W3150A+/W5100 Errata Sheet

Document History

Ver. 1.0.0 (OCT. 27, 2007)	First release (erratum 1)
Ver. 2.0.0 (SEP. 10, 2008)	Add W5100 solution for erratum 1 Remove Recommendation for erratum 1
Ver. 2.1 (APR. 5, 2010)	Remove the erratum solution for W5100 in v2.0 and bring back the recommendation of v1.0
Ver. 2.2 (FEB. 17, 2012)	Add erratum 2, 3
Ver. 2.3 (MAR. 5, 2012)	Add a solution for erratum 2, 3
Ver. 2.4 (OCT. 28, 2013)	Add a description of solution for erratum 2
Ver. 2.5 (JUL. 7, 2014)	Modify a description of solution for erratum 2
Ver. 2.6 (OCT. 5, 2015)	Not support SPI mode 3

Figure 1. General network

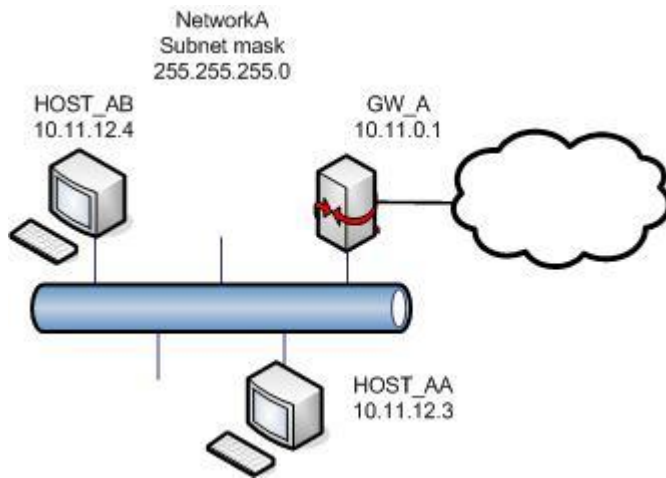
In Figure 1 network,

1. Open UDP socket in AA. Port number is 1000.
2. Send UDP data packet(destination port number 1000) from AB to AA.
3. AA processes the UDP data packet from AB.
4. Host MCU in AA runs SEND command to send.

When completion of 3 in AA (i.e. AA assert RECV interrupt), AA also runs 4 (i.e. run SEND command). In that case, do not complete process 4 due to errata.

Solution	In case of W3150A+, If you can monitor the RXDV signal (in MII interface), you can solve this problem. Before you execute SEND/SENDMAC command in UDP/IP-Raw mode, check the value of RXDV signal is '0'. That means there is no received data packet, so you can avoid the errata condition. Refer to following pseudo-code. <pre>/* Change sendto() function */ Function sendto() { ... While (RXDV == '1') ; SEND command; /* Complete Sending */ }</pre>
Recommendation	In case of W5100, We don't have solution but we can give a recommendation. After complete a transmission process, check whether Sn_TX_RD and Sn_TX_WR have same values or not. If both values are still different, close the socket and reset by force. <pre>/* Change sendto() function */ Function sendto() { ... /* Complete Sending */ /* wait until Sn_TX_WR and Sn_TX_RD are same */ While (Sn_TX_WR != Sn_TX_RD) { wait some time; loop_cnt++; if (loop_cnt > CONST_BLOCK_CNT) goto RESET } }</pre>

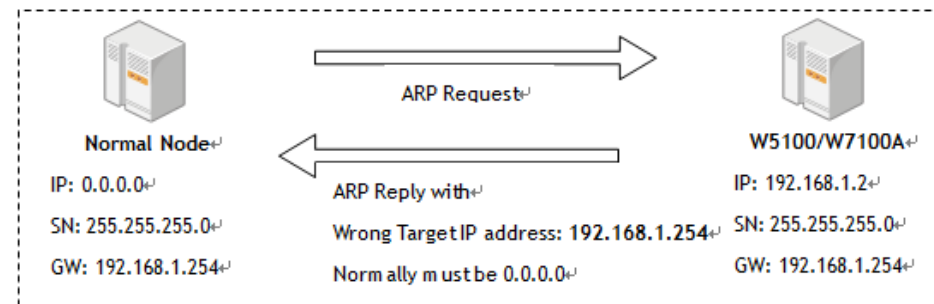
The W5100 replies with gateway IP address for the ARP request from network node which has "0.0.0.0" IP address. But normally the W5100 should replies with target IP address "0.0.0.0" not the gateway IP address.

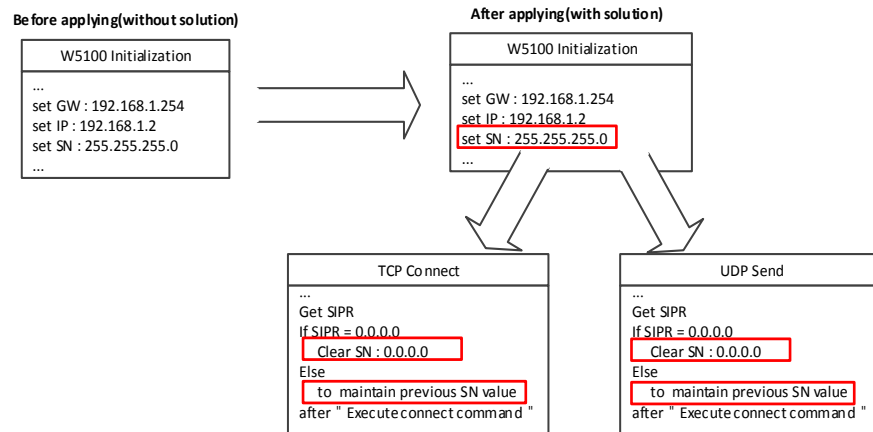
The main reason of this erratum is subnet calculating logic. The W5100 misunderstands the node locates other sub-network when target has "0.0.0.0" IP address. So the W5100 set the target IP to the gateway IP instead of "0.0.0.0" and sends the ARP reply.

To avoid this erratum we must keep the subnet mask register value to setting value except two cases which are "CONNECT" command in TCP and "SEND" command in UDP. Because only these two cases are referring the subnet mask register and sending the ARP request.

So set the subnet mask register to "FF.FF.FF.xx" and keeping it but save the right subnet mask value to the global variable when you initialize the W5100. When you use connect command in TCP or send command in UDP, set the subnet mask register to zero using the variable before executing connect or

send command. After done connect or send command, sets the subnet mask register again to keep its value to “FF.FF.FF.xx”.

In the case of applying, you can’t use the subnet broadcasting.

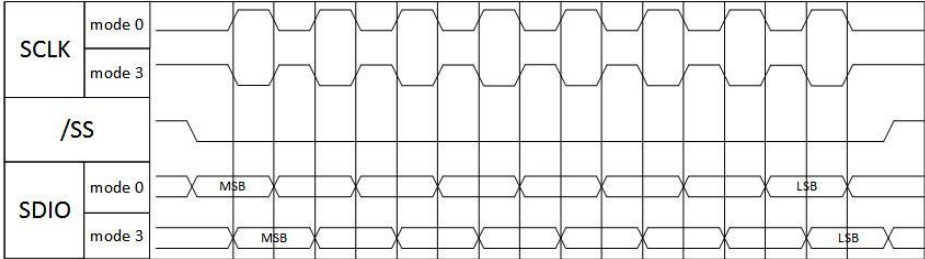
Erratum 3	
Phenomenon	Assuming that the IP address of W5100 is "0.0.0.0" and the gateway, subnet mask is valid (not "0.0.0.0"), the W5100 set the target IP address of ARP request to the gateway IP address not the target node IP address when sends ARP request to another node. So the peer node cannot receive the ARP request from the W5100.
Condition	 Normal Node IP: 192.168.1.3 SN: 255.255.255.0 GW: 192.168.1.254 W5100/W7100A+ IP: 0.0.0.0 SN: 255.255.255.0 GW: 192.168.1.254 ARP Request with Wrong Target IP address: 192.168.1.254 <u>Normally must be 192.168.1.3</u> The W5100 miss calculates the sub-network location when sends the ARP request if its own IP address is "0.0.0.0". In the same condition, even if the gateway IP address is "0.0.0.0", the W5100 sends ARP request to "0.0.0.0" IP address because the W5100 sends ARP request to the gateway.
Solution	The reason of this erratum3 is same as erratum2 so the solution is also same with erratum2. Please refer to the solution of erratum2.
